## STAFF RECOMMENDATION 1703 Beechwood Avenue May 21, 2014

**Application:** New construction-addition; Setback determination  
**District:** Belmont-Hillsboro Neighborhood Conservation Zoning Overlay  
**Council District:** 18  
**Map and Parcel Number:** 11704013500  
**Applicant:** Stewart Bronson, Stone Oak Builders, LLC  
**Project Lead:** paul.hoffman@nashville.gov

<p><b>Description of Project:</b> The applicant proposes a rear addition to this contributing home. A setback determination is requested for the addition, from five feet (5') to three feet six inches (3'6") on the east side. The existing home sits approximately two feet (2') from that property line. The project includes a basement-level rear attached garage.</p> <p><b>Recommendation Summary:</b> Staff recommends approval with the conditions:</p> <ul style="list-style-type: none"> <li>• That Staff have final approval of the windows, doors and garage door, roofing color and a brick sample;</li> <li>• The front two windows on the right side of the existing house shall remain; and,</li> <li>• HVAC be located on the rear façade, or on a side façade beyond the midpoint of the house.</li> </ul> <p>Meeting these condition

**SITE PLAN  
FOR  
1703 BEECHWOOD AVE.**

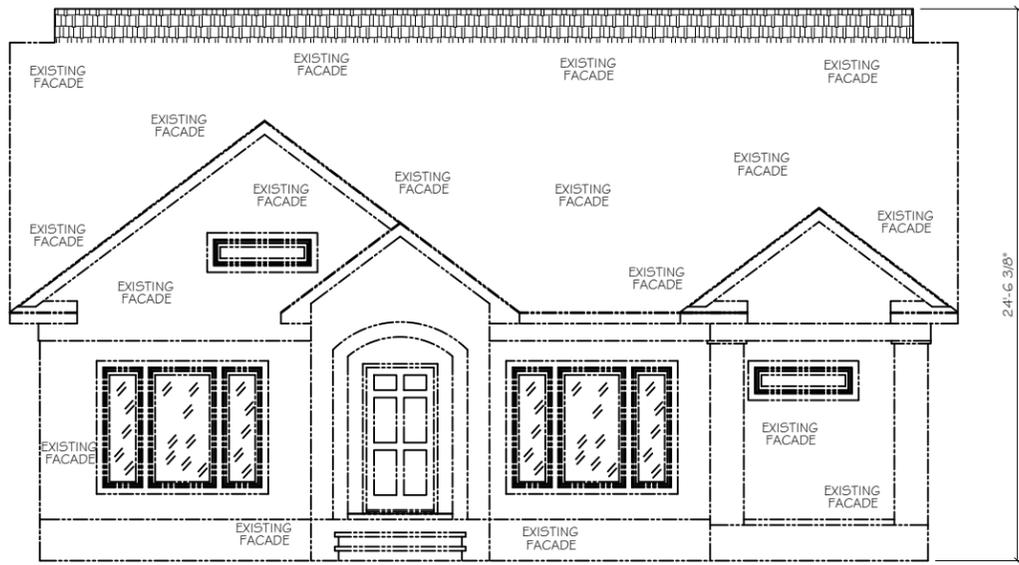
Setback & Rhythm of Spacing: The front setback will not change. The sides of the addition will be five feet (5') and three feet six inches (3'6") from the side property lines, and approximately sixty feet (60') from the rear property line. The project requires a setback determination for the east side property line. The Commission's policy for granting setback determinations includes the condition where a historic building does not meet the current setback requirements. Because the existing house already sits just two feet (2') from that side property line, and the addition is not wider than the house, Staff finds the setback determination to be appropriate. The project meets section II.B.1.c.

RIGHT ELEVATION  
1/8" = 1'-0"

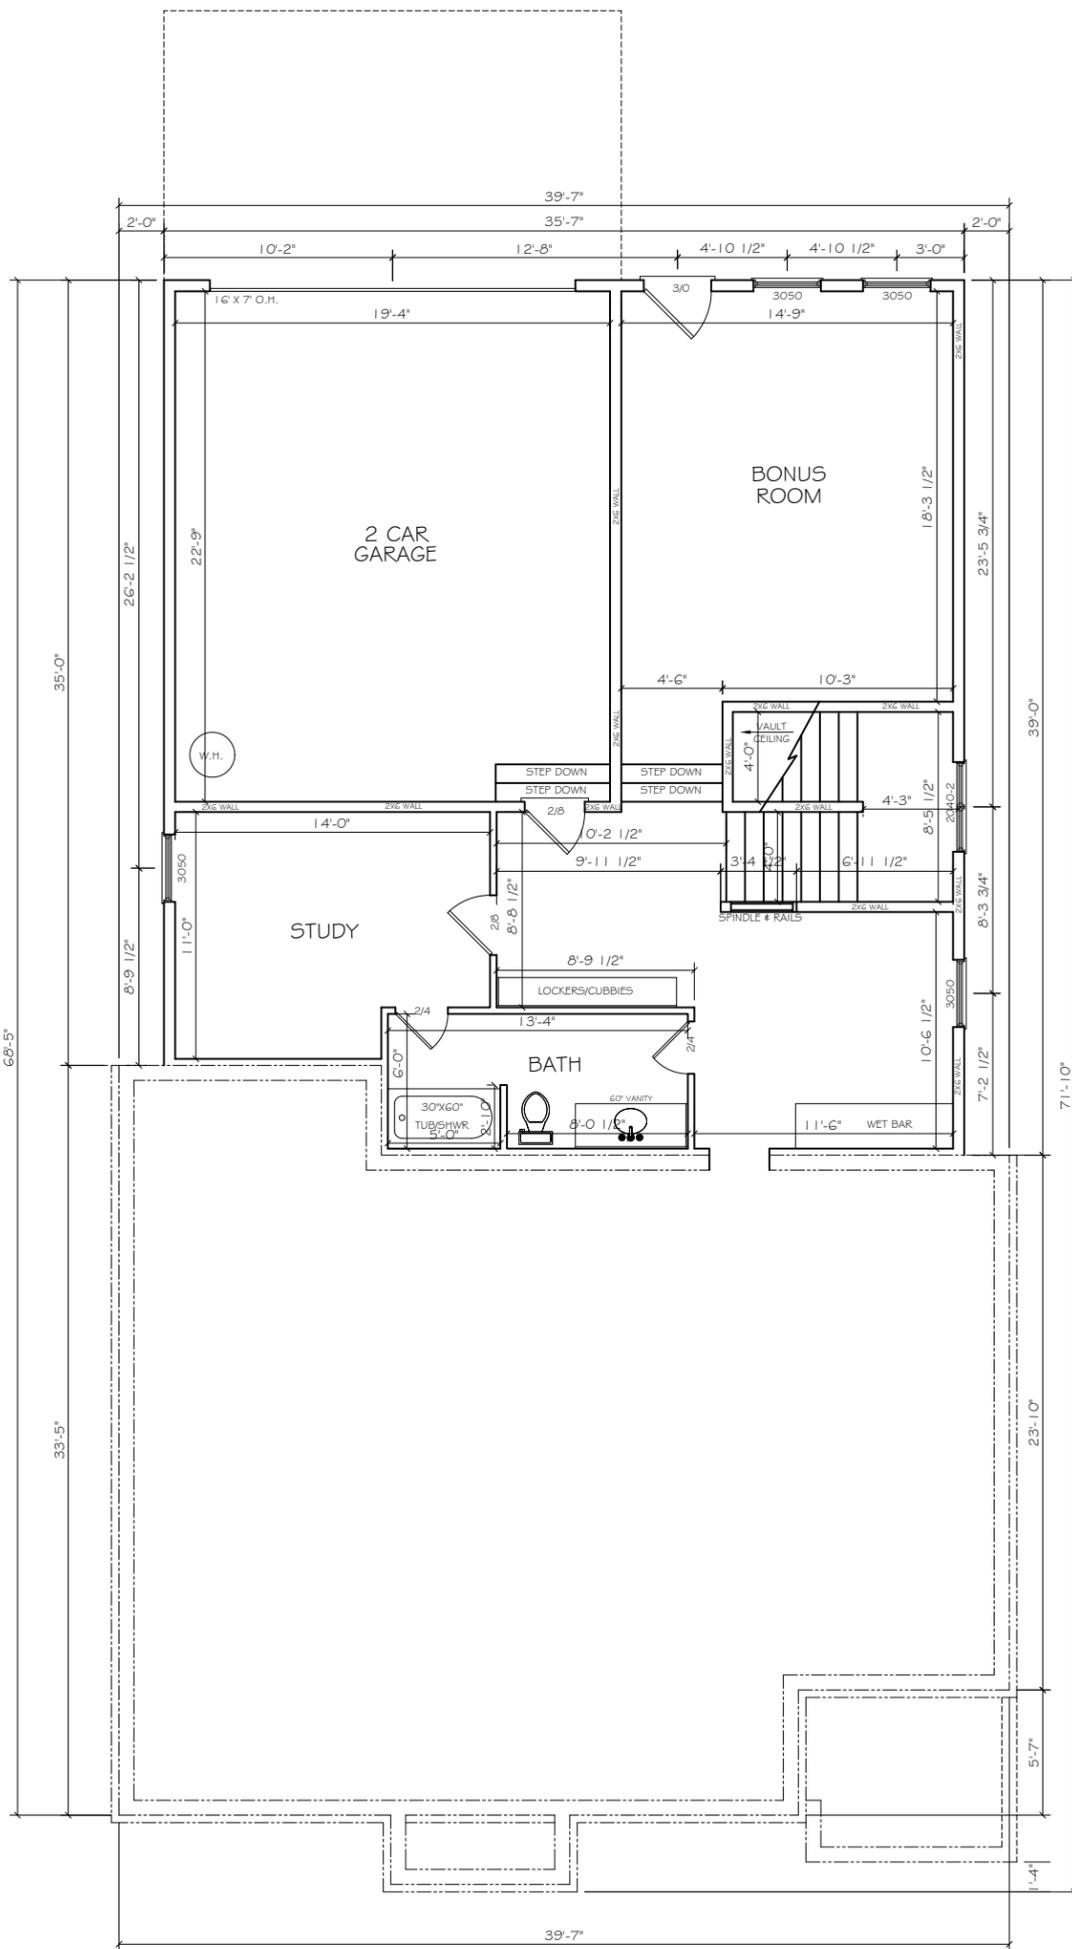
Proportion and Rhythm of Openings: Plans indicate changes to the window openings on the existing house. The existing windows are likely original to the home, but when homes are close together, the Commission has allowed windows toward the rear to be altered. Staff recommends maintaining the existing front two windows on the right elevation. The horizontal window openings on the left elevation are unusual, but not character-defining. Staff finds their replacement by more historically-proportioned window openings to be appropriate.

Most of the windows on the proposed addition are generally twice as tall as they are wide, meeting the historic proportions of openings. Horizontal windows on the right elevation and rear are acceptable in these minimally-visible locations. The longest expanse of wall space without a window or door opening is approximately twenty-eight feet (28'), but this is on the basement level and at the rear of the addition, and will not be visible. With the condition that the front two window openings on the right elevation of the existing house remain, Staff finds the project's proportion and rhythm of openings to meet Section II.B.1.g and II.B.2.

- That Staff have final approval of the windows, doors and garage door, roofing color and a brick sample;
- The front two windows on the right side of the existing house shall remain;
- HVAC be located on the rear façade, or on a side façade beyond the midpoint of the house.
